DEVELOPMENT REVIEW COMMITTEE (DRC) COMMENT REPORT

PROJECT NAME: Hotel d'Arts

CASE NUMBER: R19051

REQUEST: Site Plan Level II Review: 100-Room Hotel and
Off-Site Parking in Northwest Regional Activity
Center

STREET DESIGN EXAMPLES: NWRAC-MU

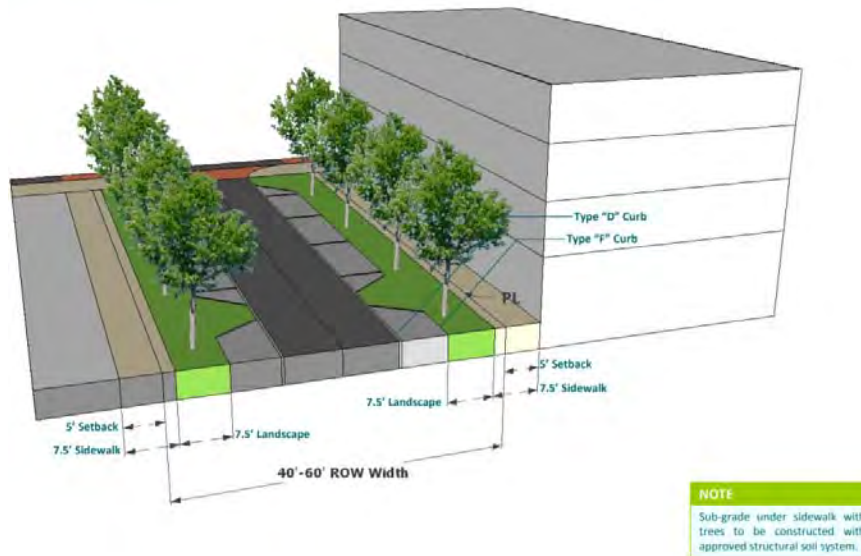
9. Provide an off-site parking agreement in order to use the proposed parking lot that is located off-site.
10. Pursuant to ULDR, Section 47-13.29.A.2 NWRAC-Illustrations of Design Standards redesign the streetscape along both NW 7th Avenue and NW 3rd Street to adhere to the street design examples. Please use the following street design examples:

b. NW 3rd Street
